SUBMITTAL OF HANFORD FACILITY RESOURCE CONSERVATION AND RECOVERY ACT (RCRA) PERMIT MODIFICATION NOTIFICATION FORM 24590-HLW-PCN-ENV-06-011

Hanford Facility RCRA Permit Modification Notification  
Form 24590-HLW-PCN-ENV-06-011

Page 2 of 2: Hanford Facility RCRA Permit, Part III, Chapter 10, and Attachment 51, Appendix 10.2  
Update HLW process and instrumentation diagrams (P&ID) 24590-HLW-M6-HCP-P0001 and 24590-HLW-M6-HCP-P0002 for the Concentrate Receipt Process System (HCP) in Appendix 10.2 of the Dangerous Waste Permit.

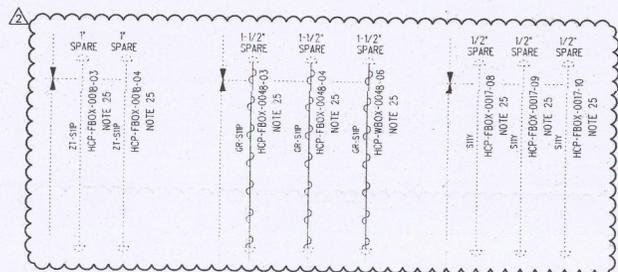
This modification addresses changes to HLW HCP P&IDs 24590-HLW-M6-HCP-P0001 and 24590-HLW-M6-HCP-P0002, located in Appendix 10.2 of the Dangerous Waste Permit. Changes to these P&IDs are principally editorial in nature.

- Changed the labels on the PTF side of the feed transfer line identifying the PTF vessels.
- Changed the labels on the HLW side of the feed transfer line regarding the return to PTF.
- Modified, deleted and renumbered notes (for consistency with engineering procedures).
- Identified Spare Penetrations

- DELETED
- DELETED
- CONTENTS OF THIS DOCUMENT ARE DANGEROUS WASTE PERMIT AFFECTING.
- MODIFIED/RENUMBERED NOTES, ADDED NOTE 25, CHANGED SEISMIC CATEGORY AND QUALITY LEVEL DESIGNATION OF FLUSH LINE. UPDATED REFERENCE, REMOVED HOLD, DELETED CONCENTRATE RECEIPT VESSEL, AND UPDATED CONNECTING FLAGS.

- INCORPORATED EDITORIAL CHANGES TO OFFSHEET CONNECTOR TEXT, MODIFIED/RENUMBERED NOTES, ADDED SPARE PENETRATIONS.

Appendix 10.2			
Replace:	24590-HLW-M6-HCP-P0001, rev. 1	With:	24590-HLW-M6-HCP-P0001, rev. 2
Replace:	24590-HLW-M6-HCP-P0002, rev. 1	With:	24590-HLW-M6-HCP-P0002, rev. 2

**P&ID - HLW CONCENTRATE RECEIPT PROCESS SYSTEM MELTER 1 TRANSFER PIPING**

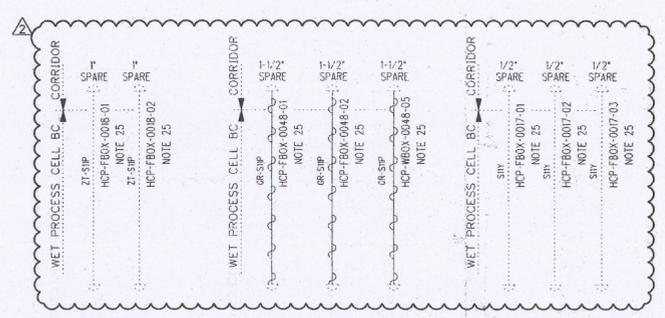
- DELETED
  - DELETED
  - CONTENTS OF THIS DOCUMENT ARE DANGEROUS WASTE PERMIT AFFECTING.
  - MODIFIED/RENUMBERED NOTES. ADDED NOTE 25. CHANGED SEISMIC CATEGORY AND QUALITY LEVEL DESIGNATION OF FLUSH LINE. UPDATED REFERENCE. REMOVED HOLD, DELETED CONCENTRATE RECEIPT VESSEL, AND UPDATED CONNECTING FLAHS.

- INCORPORATED EDITORIAL CHANGES TO OFFSHEET CONNECTOR TEXT, MODIFIED/RENUMBERED NOTES, ADDED SPARE PENETRATIONS.
